Office Action Summary	Application No. 10/685,139	Applicant(s) MITCHELL, STEVE	
	Examiner MARY HOFFMAN	Art Unit 3733

DETAILED ACTION

CLAIMS 9, 13-18 and 20-24

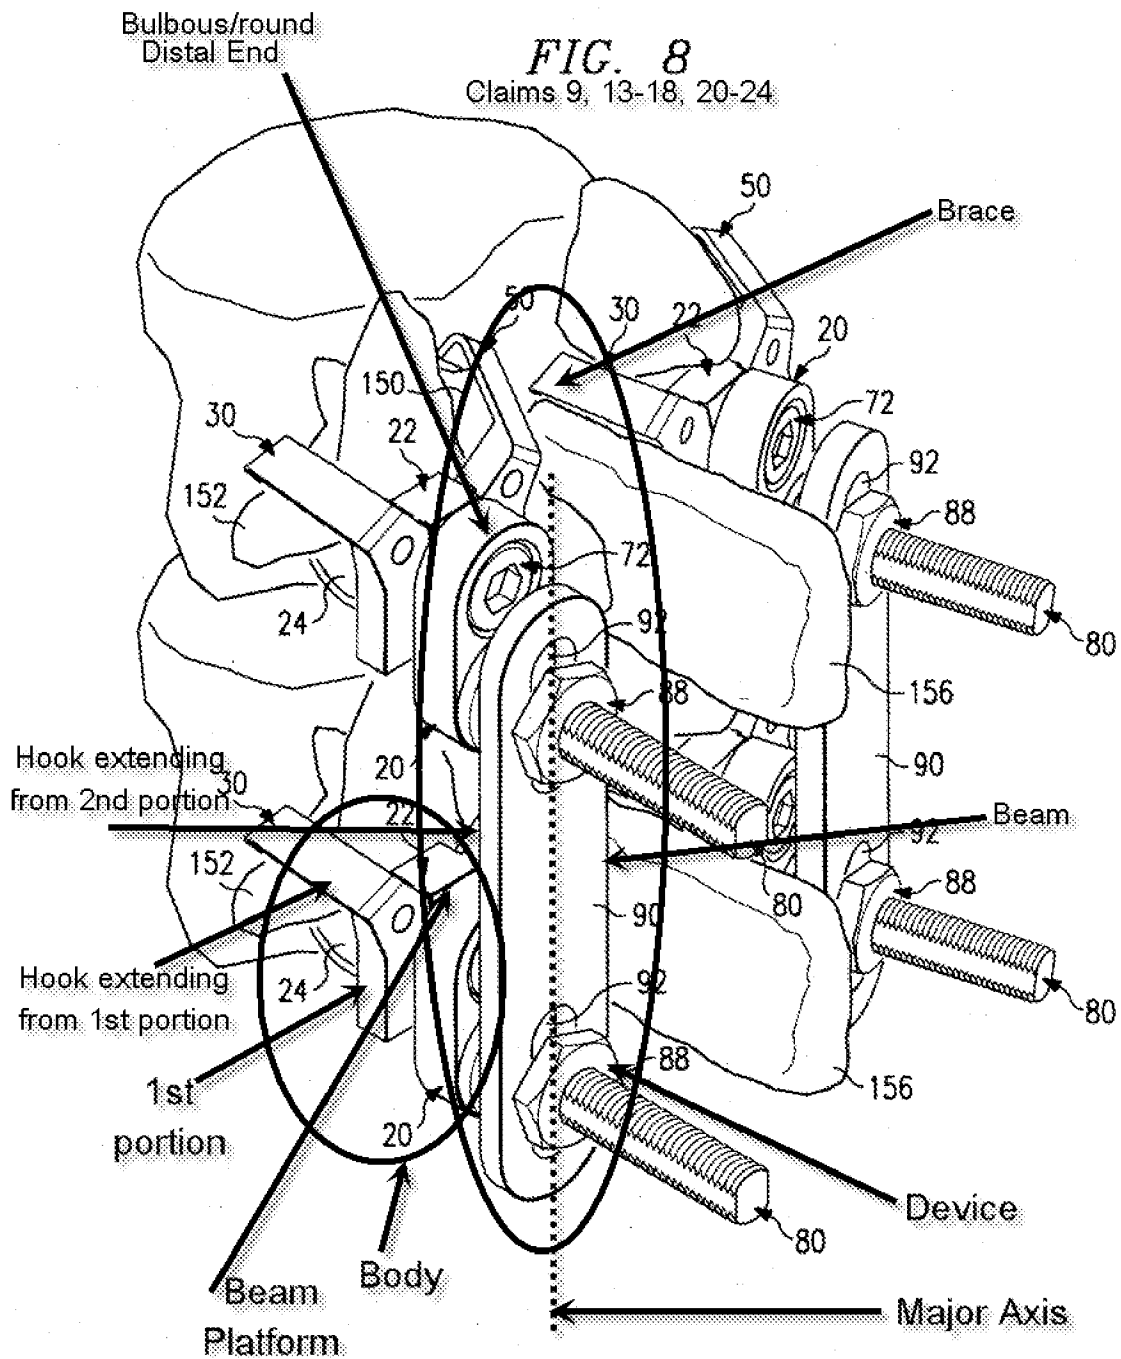
Claims 9, 13-16, 20-24 and 82 are rejected under 35 U.S.C. 102(b) as being anticipated by Lee et al. (U.S. Patent No. 5,415,659).

Lee et al. discloses the claimed invention. The rejection is illustrated in the below marked-up figure. The claims features are labeled in the below marked-up figures.
